ICHD–ENVIRONMENTAL HEALTH DIVISION

Statesville Office (704) 878-5305 | Mooresville Office (704) 660-3625 | PERMIT # AP307051

SEPTIC IMPROVEMENT PERMIT / AUTHORIZATION TO CONSTRUCT / OPERATION PERMIT / EXISTING SYSTEM

SITE ADDRESS: 535 Lake Circle Troutman NC 28166 | PHONE: 704-614-7781 | ALT. PHONE

INITIAL SITE SKETCH

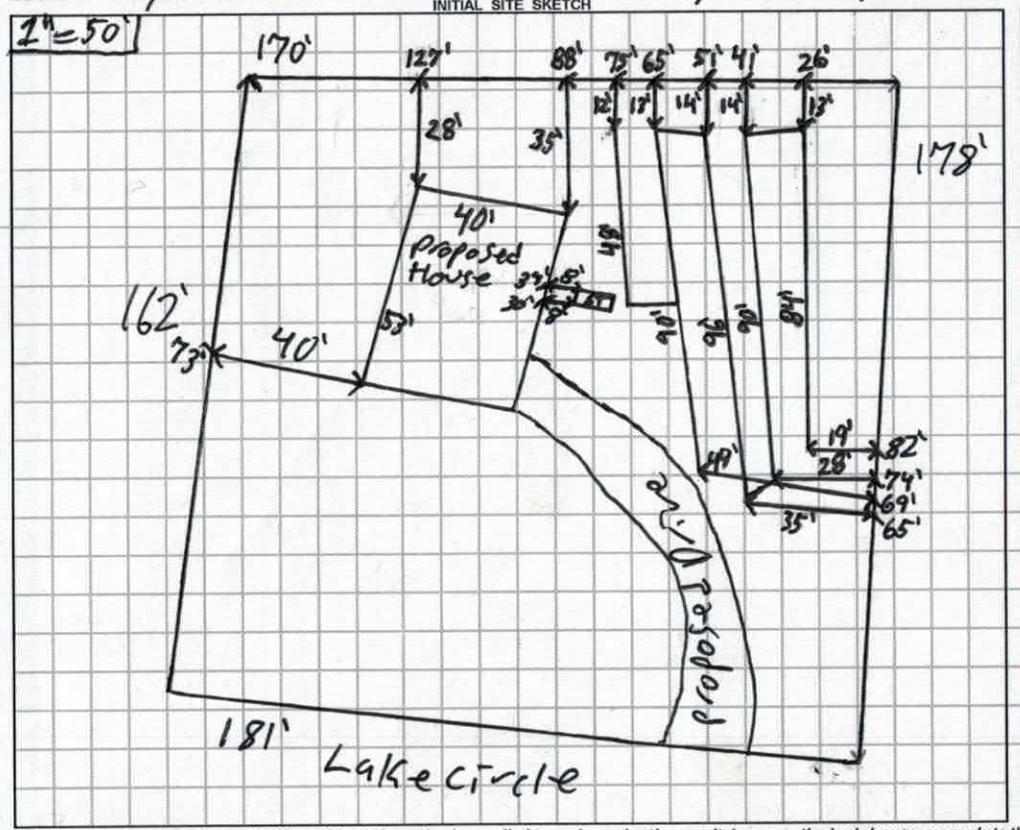
Comments / Conditions: NO Foundation drains can be installed on side of House closest to septic system. Recommend diverting storm and surface water Away from septic Area

Water Line must be 10' off septic Area. Drive needs to be shifted off of drain Lines.

INITIAL SITE SKETCH

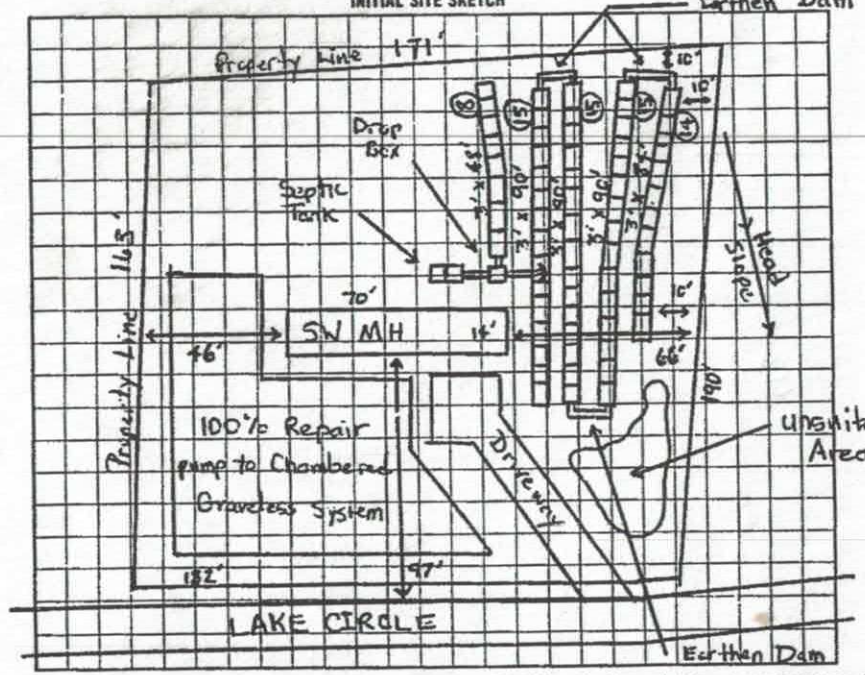
Comments: Install Chambered Graveless system on Contour of land. INSTALL SHALLOW (no deeper than 24" to trench bottom). Keep System min. 5' from foundation of house, 10' from all property lines, and min. 50' from any well. Also 10' from water line. Install 67 chambers total. Bring in enough sand to fill around trenches any part of system.

Comments: Home not located at time of inspection. Keep it min. 5' from any part of septic system. Keep water line min. 10' from any part of Septic System. Install driveway off of septic system. Do not drive over
